HDV GTR achievements and discussion EVE IWG 74th session

September 18th
-online-

3 general comments

Example: Re-definition of PTO and add ePTO

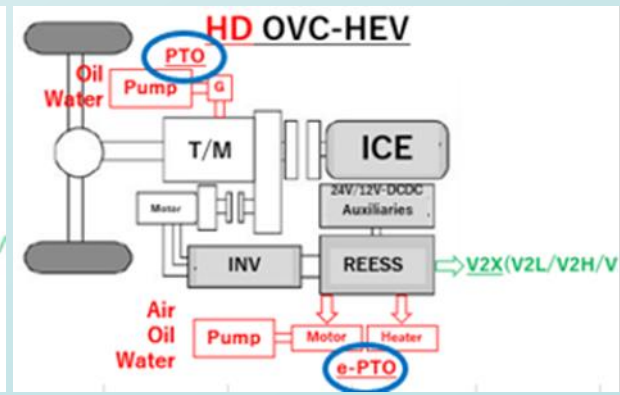
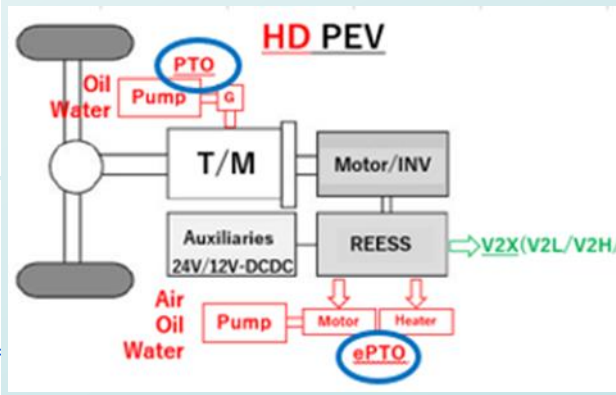
Definitions 2.51. of UN-R49-07 defines "PTO unit", but since PEV/OVC-HEV has the following PTOs, So new definitions of PTO and ePTO are required. (see below 3.17 and 3.**)

3.17. Power take-off (PTO) means supplying power from the engine (ICE, motor) to operate auxiliaries equipment unrelated to vehicle traction or normal vehicle auxiliaries(24V/12V-DCDC), such as oil pumps, water pumps (for concrete mixers, garbage trucks, fire trucks etc.)

3.**. Electrical Power take-off (ePTO) means a directly REESS that provides substantial auxiliary power for purposes unrelated to vehicle propulsion or normal vehicle accessories (Heater, 24V/12V-DCDC) such as air pump, oil pump, water pump (for Cargo Thermal Control trucks, Refrigerator trucks, Cabin heater and air-conditioning etc...)
